RE: S/D 98-101 -- One-Step Final Plat of U-NEEDA SELF STORAGE ADDITION

RE: S/D 98-101 -- One-Step Final Plat of U-NEEDA SELF STORAGE ADDITION

STAFF REPORT
(One-Step Final Plat Approved 11/5/98)

CASE NUMBER: S/D 98-101 - U-NEEDA SELF STORAGE ADDITION

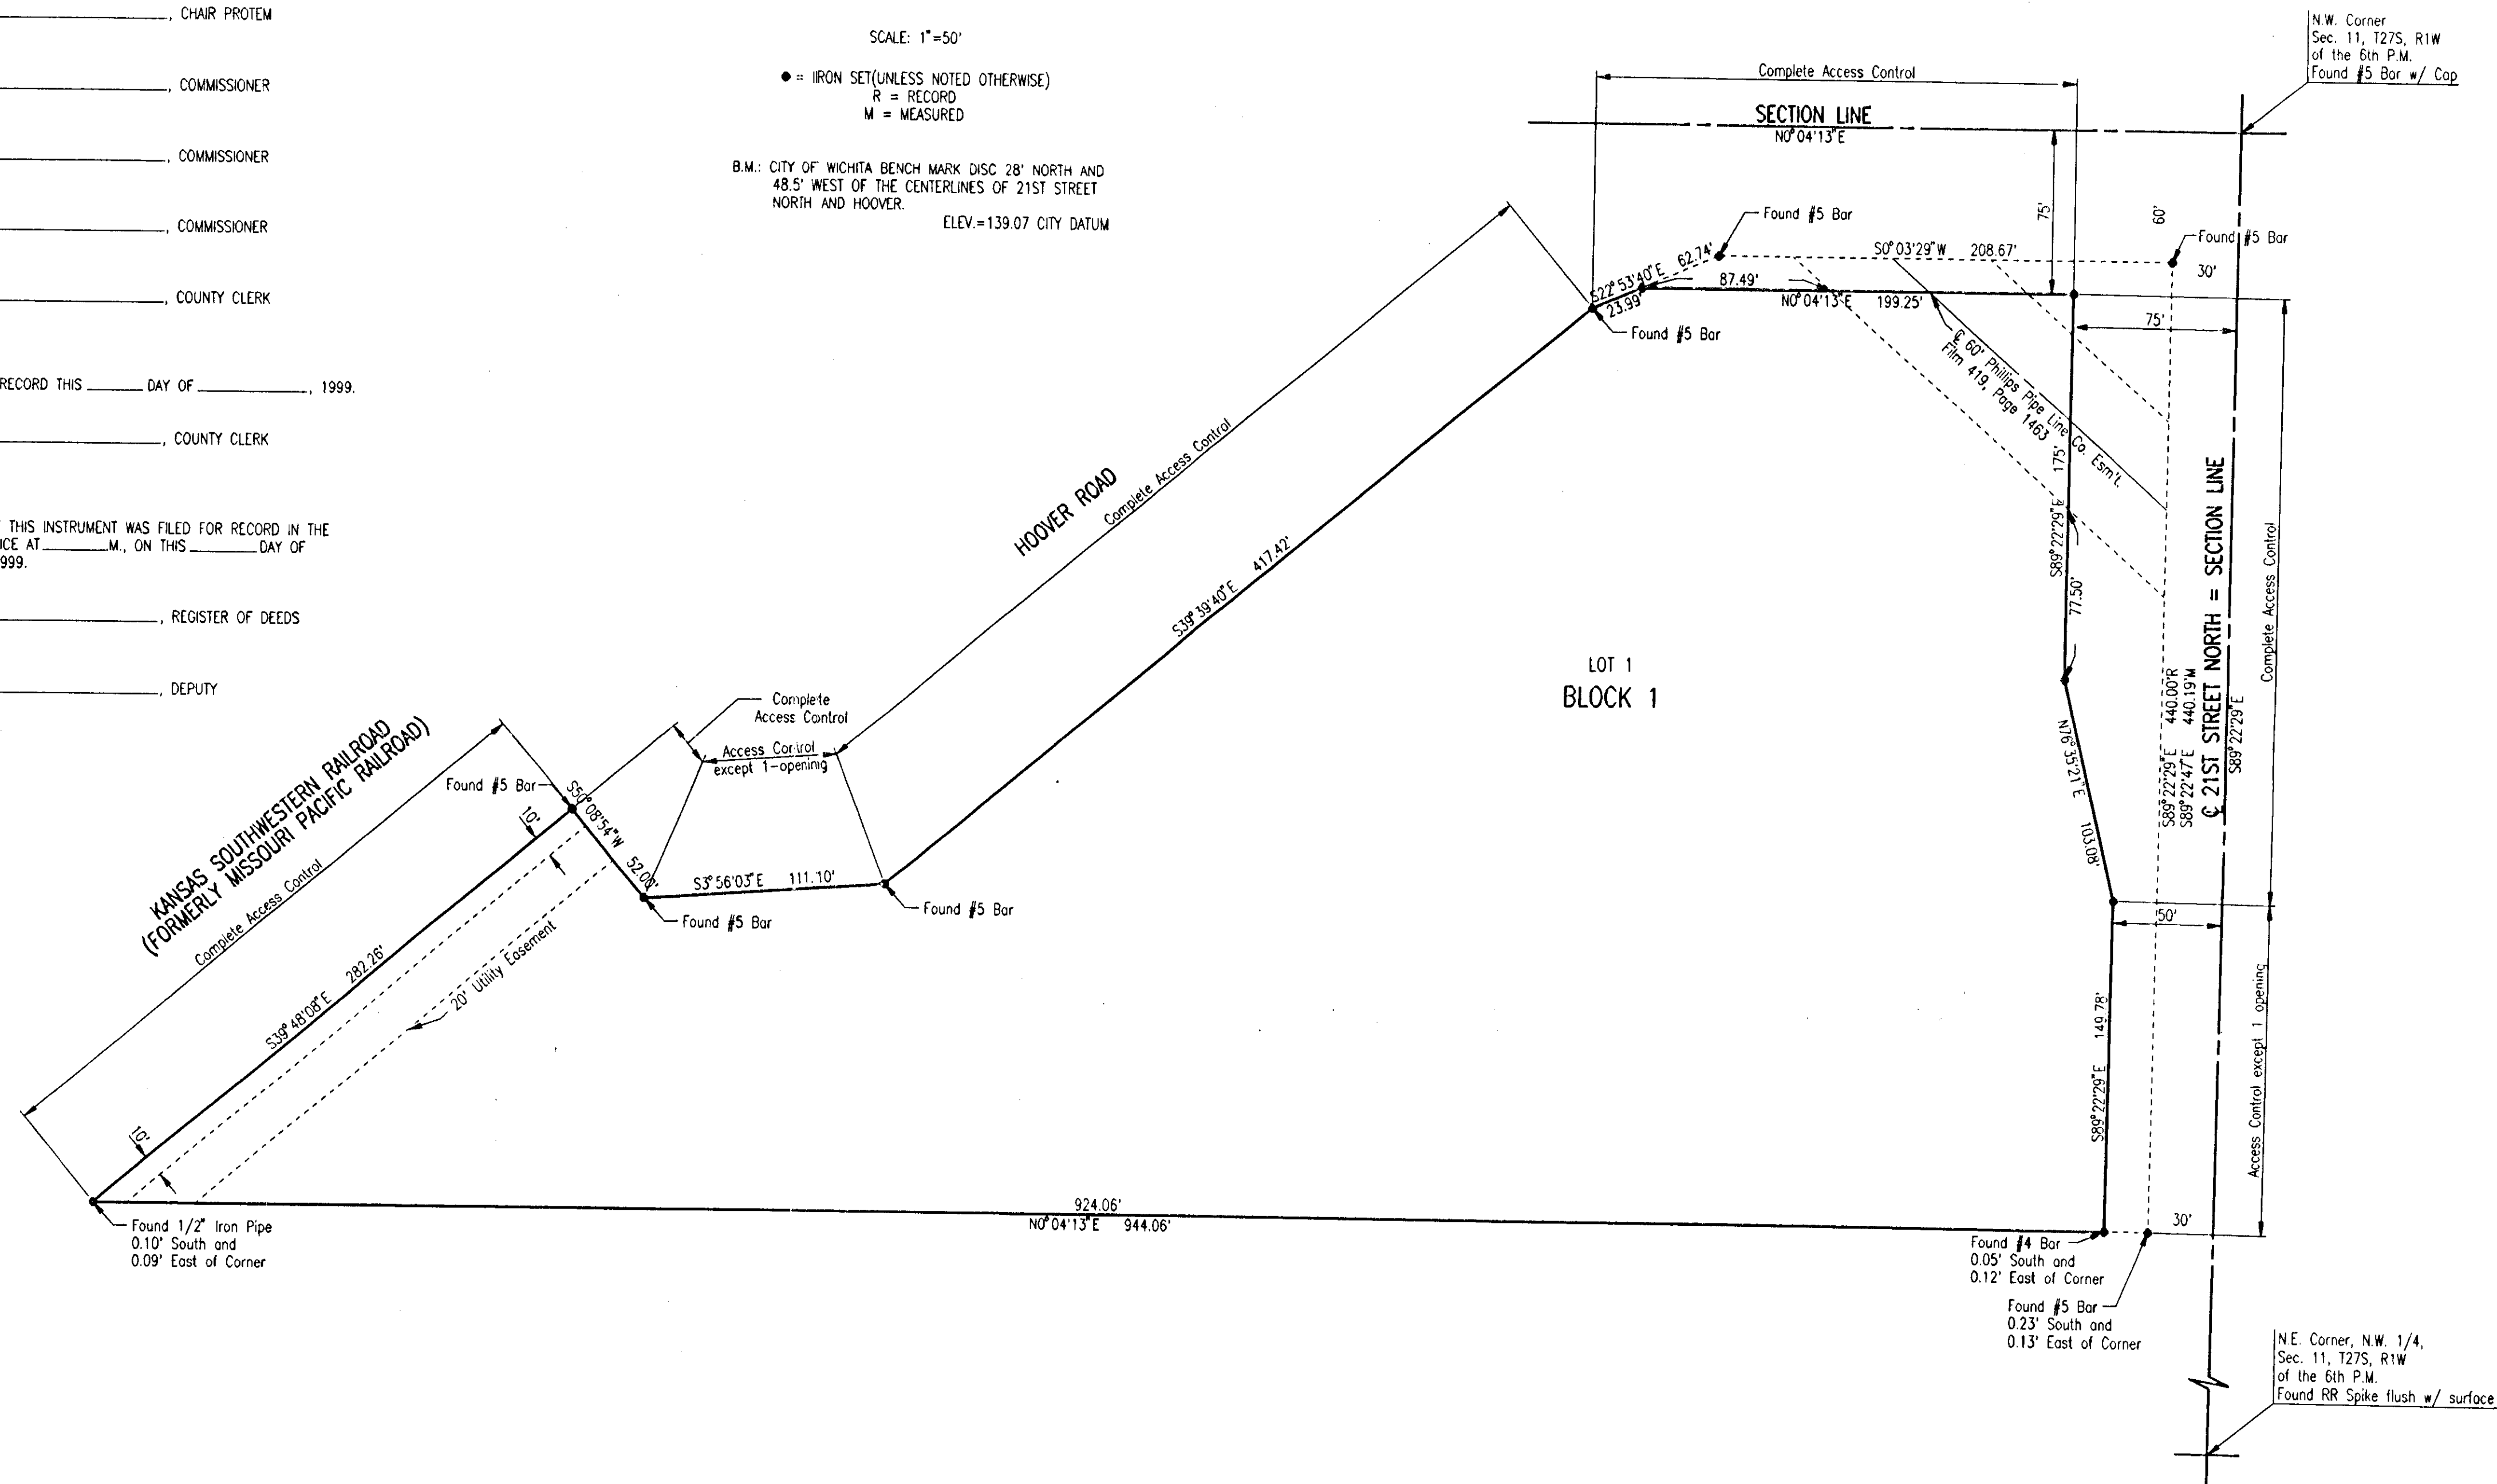
- F. The zone change was approved subject to conformance with a site plan which denoted one access opening along Hoover on the southern portion of the plat and one opening along 21st St. North. The plat is not in conformance with the site plan, as it denotes two openings along Hoover. Distances should be shown for all segments of access control. Traffic Engineering and MAPD require one opening along Hoover. County Engineering requires complete access control be obtained along the railroad right-of-way.

- G. The plat's text should reference the dedication of right-of-way for Hoover and 21st St. North.
- H. In addition to the pipeline easement platted on this site, the platting binder indicates there is another pipeline easement located on the property. The Applicant shall either obtain a release of the easement or denote its location on the final plat tracing.

- F. The zone change was approved subject to conformance with a site plan which denoted one access opening along Hoover on the southern portion of the plat and one opening along 21st St. North. The plat is not in conformance with the site plan, as it denotes two openings along Hoover. Distances should be shown for all segments of access control. **Traffic Engineering and MAPD require one opening along Hoover. County**

- G. The platlor's text should reference the dedication of right-of-way for Hoover and 21st St. North.
- H. In addition to the pipeline easement platted on this site, the platting binder indicates there is another pipeline easement located on the property. The Applicant shall either obtain a release of the easement or denote its location on the final plat tracing.

Engineering requires complete access control be obtained along the railroad right-of-way.
